802.3dj D3.1

Comment Resolution

Optical Topics

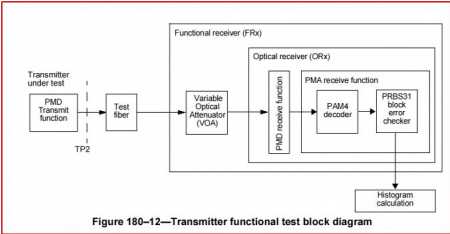
This says "the best estimate of the actual MPI and DGD penalties of the test fiber", yet the fibre alone doesn't make much MPI. The reflections between transmitter and connectors, and receiver and connectors, are more important. It is not clear which reflections are taken as baseline and which are attributed to the fibre, particularly as both transmitter and receiver reflectances are not necessarily at the spec limits. MPI varies with polarisation yet there is no polarisation control in Figure 180-12.

If the TFT section is kept;
if MPI penalty variations are important, explain how the MPI penalty is to be estimated and add polarisation control. If MPI penalty variations are not so important or not feasible to estimate with confidence, use a fixed allocation

The transmitter under test is connected to the FRx by a test fiber which meets the requirements in 180.9.6.2. Full compliance with 180.9.6.2 requires the test fiber to provide back reflection with polarization state resulting in the greatest RIN. Other test fibers, including patch cords, may be used for additional tests.

→ Allowing users to set MPI_DGD_Penalty to 0, or other value based on test setup conditions.

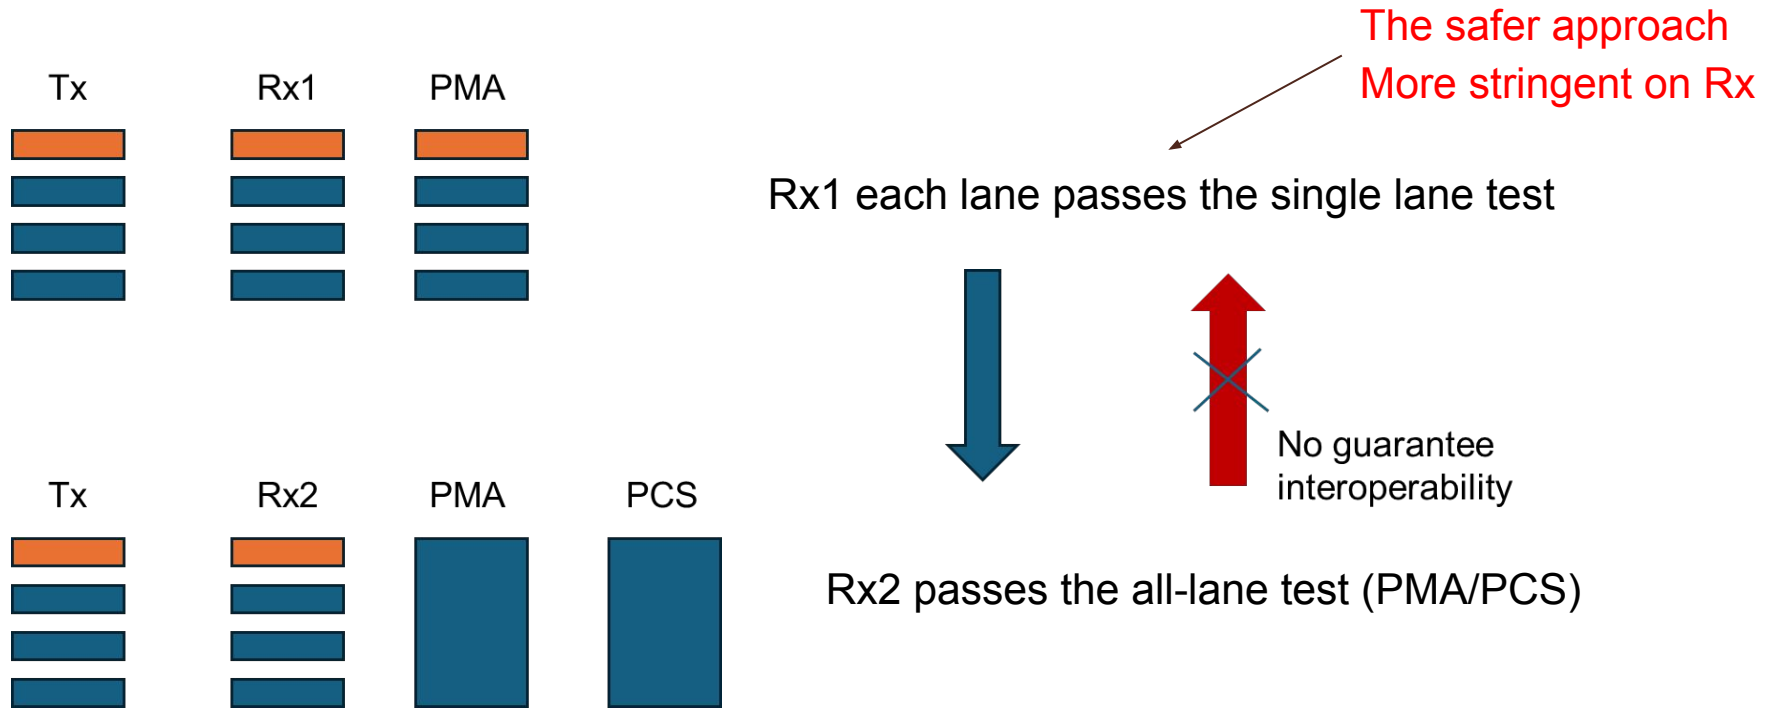
This comment is in support of comment i-493 against D3.0. For a multilane system what matters is the Frame Loss Ratio of the interface which is a function of the performance of all the lanes. It is not necessary for all the lanes to meet the specification here. Also it is not possible to test the performance of the individual lanes when using scrambled idle (pattern 5). Also the test method called out in 174A.9.6 (allowed by page 492 line 2) specifically allows is a multilane test.

Implement the following changes:

delete pattern 5 from test pattern specified for receiver sensitivity and Stressed receiver sensitivity in Table 180-13.

delete reference of 174A.9.6 from the receiver sensitivity methodology.

Delete the note that begins with "When measuring receiver sensitivity of a complete PHY at the PCS...."

Add an exception in 180.9.14 and 180.9.15 that, when testing using 174A.9.5 or 174A.9.7, the compliance may not be further verified using 174A.9.6.

BLER test method for all lanes 174A.9.6

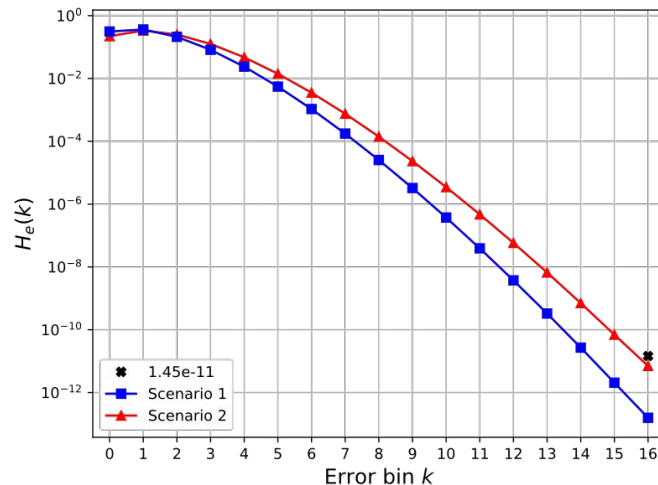
Assume four optical lanes 0,1,2,3, consider two scenarios:

1. BER over four lanes is [3e-4, 1e-4, 1e-4, 1e-4]
2. BER over four lanes is [2.5e-4, 2e-4, 2e-4, 2e-4]

Calculate $H_e(k)$ with $BER_{added} = 6.4e-5$, and compare $H_e(16)$ with $1.45e-11$

Both scenarios pass the test method for all lanes, but with $BER > 2.28e-4$ for lane 0.

Propose to use only the per-lane test method for receiver sensitivity, and define receiver sensitivity as per-lane property

Figure 180–9—TDECQ conformance test block diagram

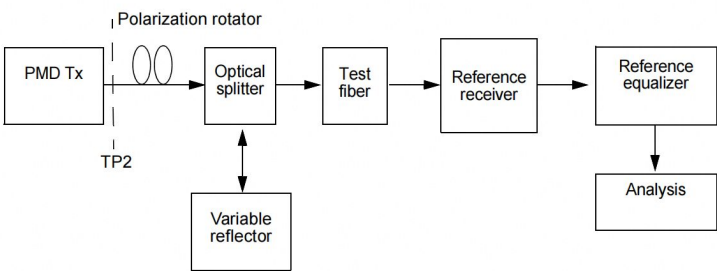
Repeating description of polarization.
